7th February 2024
Ref: 3035-pj-PP3

Planning Application: Hornsey Parish Church; Cranley Gardens N10 3AH;
Your reference: HGY/2023/3381

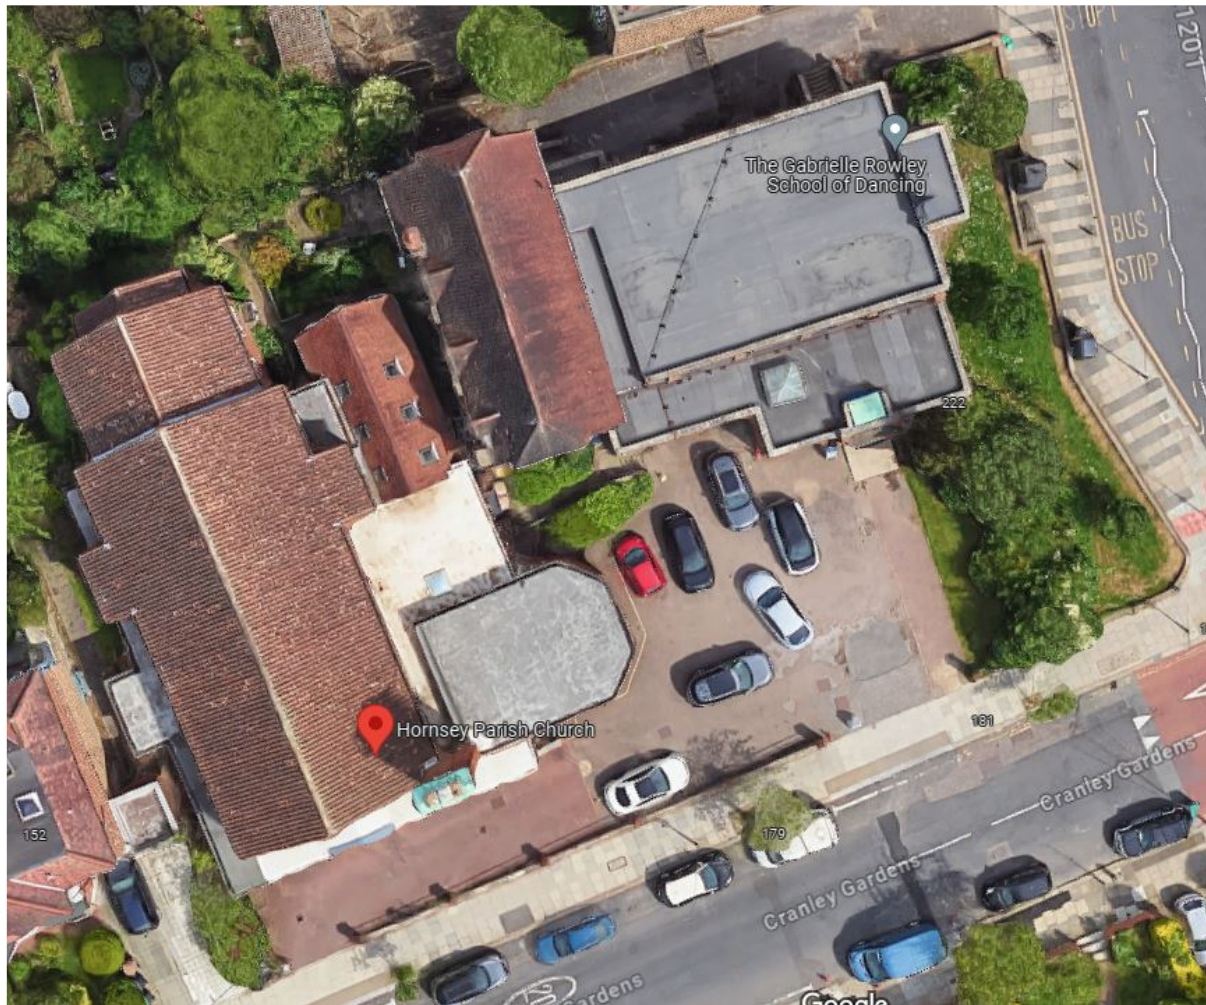
b. The site presently has 8 parking spaces that are to be retained – a site layout plan illustrating these parking spaces should be provided.

It is correct that up to eight cars are regularly to be found in the parking area. This can be independently verified by the scene on Google Earth (below) which happens to show seven. These spaces are not currently demarcated by lines and park in a more “random” pattern, but for illustrative purposes these are shown on the attached plan. These cars exit the site by the wider (east) exit. It may be of particular interest to the officer and support to the application that in the current Google Earth view a white car is parked with a folding bollard to its rear. The parking layout is not part of the current proposals but a demonstration that the existing arrangement works.
